Concerned Products:	Customer Notification		Date: May 3, 1999
μPD789011 μPD789012 μPD78P9014			Bug Report
Jan. 28th, 98		Doc. No.: TPS-LE-B-S001	
1 st revision	: May 3, 99	Doc. No.: TPS-LE-B-S001-1

(A) BUG LIST

(B) BUG DESCRIPTION

Figure P30 Block Diagram

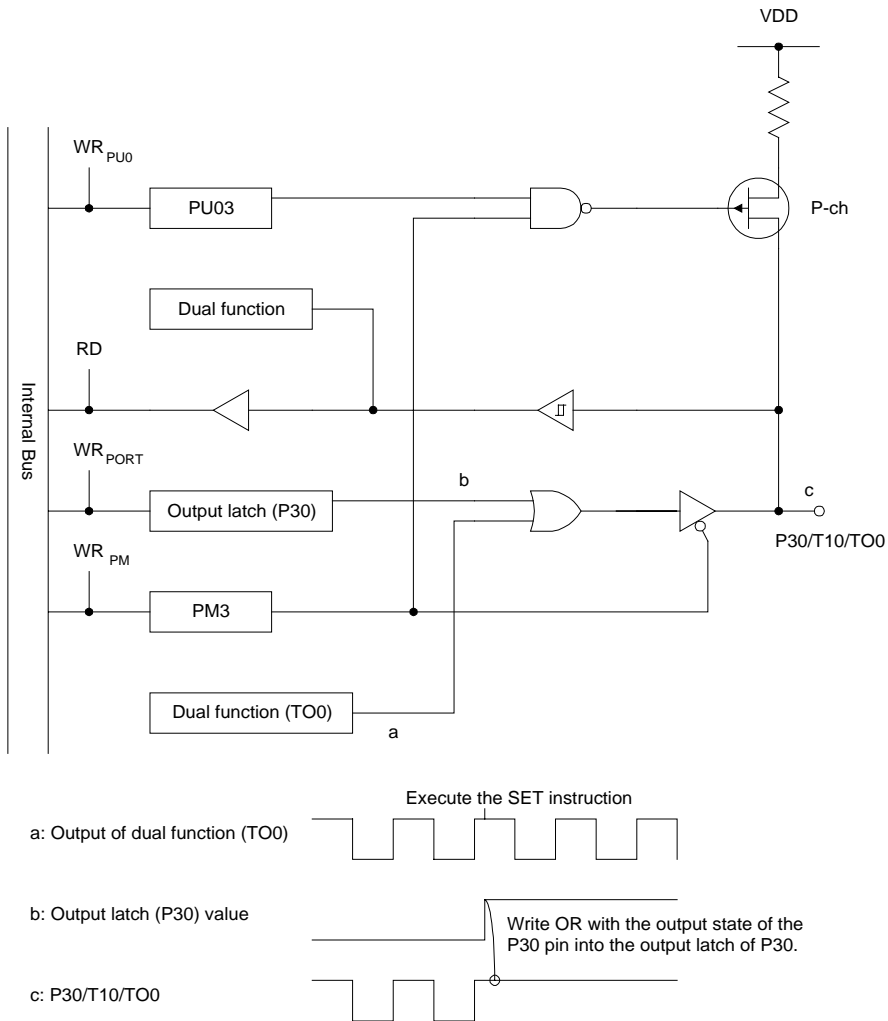
Bug No.	Outline	Description
1	Bit and logical operation at ports 2 and 3	<p>Details</p> <p>Avoid to use bit operation instructions and logical operation instructions on Ports 2 and 3(dual function pins). Instead of this, be sure to use 8 or 16-bit data transfer instructions to control output ports 2 and 3.</p> <p>Reason for operating precautions Executing bit operation instructions (SET1, CLR1) and logical operation instructions (OR, XOR, etc.) on the ports (2 and 3) which have the dual functions of timer output and serial interface may cause the contents of the dual function pins to be different from the expected values. This is because the bit operation instructions and logical operation instructions of the μPD789011, 789012 and 78P9014 are not for performing operations on the contents of the output latch but for performing operations on the status of the relevant pins.</p> <p>We have no plans to change the device circuits.</p> <p>For your reference, Attachment 1 shows an example of executing the SET1 instruction on P32 causing P30 to be fixed to "H" and Attachment 2 is listing the ports and instructions relevant to this precaution.</p>

- ① Uses P30 as the TO0 output to execute “SET1 PORT 3.2” while TO0 is outputting a high level.
- ② The CPU reads all the pin statuses of Port 3 in response to the SET1 operating instruction, sets the relevant bit (P32 in this example) and writes the result to the latch of the Port 3.
- ③ When this SET1 instruction was executed, pin P30 was high level. This results in a high level being written to the output latch of P30, thus causing the pin’s output to be fixed to high level. (When outputting TO0, it is necessary to set the output latch to low level first.)
